V2500-A1 SERIES PROPULSION SYSTEMS SERVICE BULLETIN

This document transmits the Revision 1 of Service Bulletin V2500-ENG-72-0125 and the Initial Issue of the Supplement.

V2500-ENG-72-0125

ENGINE – LP TURBINE – INCORPORATE LPT DISK AND DIFFUSER SUPPORT ASSEMBLY NUTS WITH
REVISED COATING

LPT rotor assembly
Figure 1

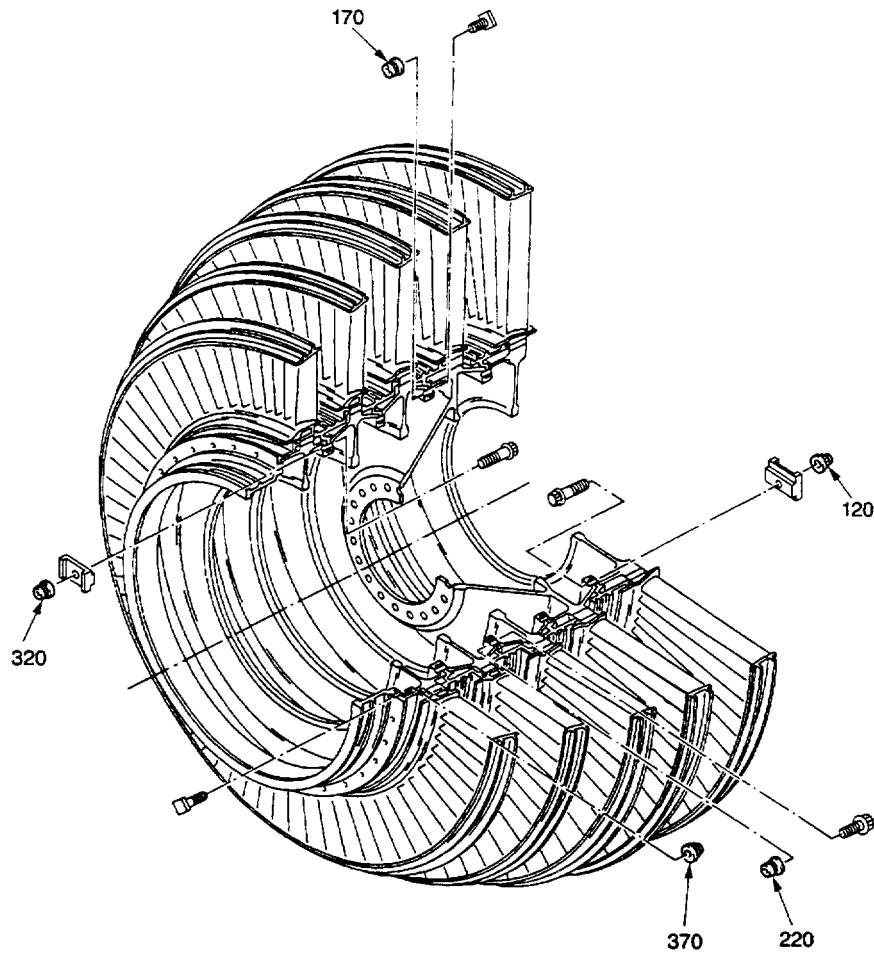
(1) New nuts for the LP turbine rotor connection with silver plating in the threaded area only are now available.

LPT Diffuser support assembly
Figure 2

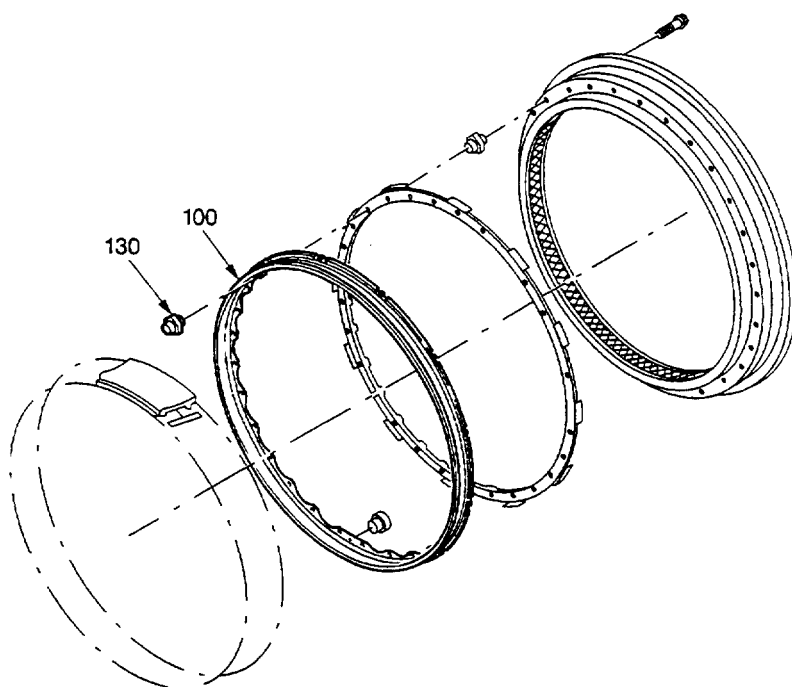
R (2) The diffuser segments can be reworked by replacing the existing clinchnuts with new clinchnuts with silver plating in the threaded area only.

Replace the nuts of the inner diffuser support
Figure 3

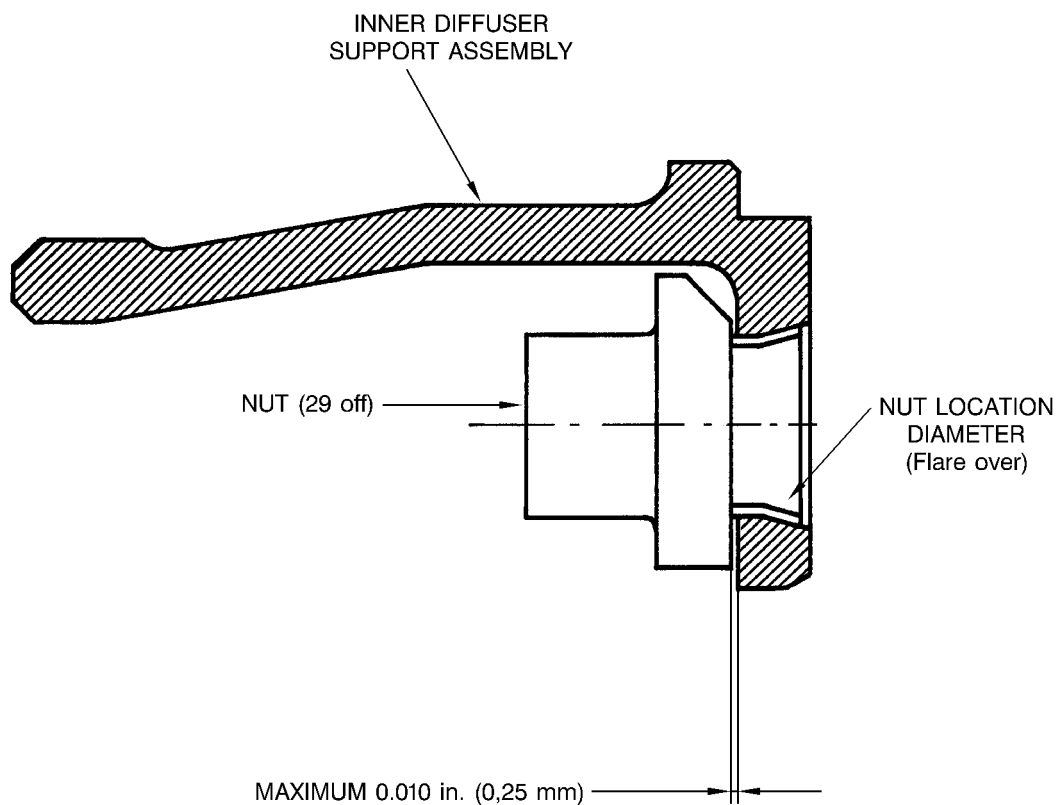
R (4) Remove the Worn Nuts of the Inner Diffuser Support Assembly
R Use electric hand drill, diameter of drill 0.27 in. (6,80 mm). Damages at the chamfer, the bore and the faces of the Inner Diffuser Support Assembly are not permitted (Refer to Fig.3).

R (6) Examine the inner diameter of the hole for damage
R Fine scratches are permitted. Remove raised material (Refer to Fig.3).
R Use needle file and stones.

R (7) Install the hollow sections of the new nuts into the holes
R Make sure that the shoulder of the nuts are installed so that the nuts cannot rotate (Refer to Fig.3).

R (8) Flare over the locations diameter of the nuts
R Axial movement of the nuts up to a maximum of 0.010 in. (0,25 mm) is permitted.
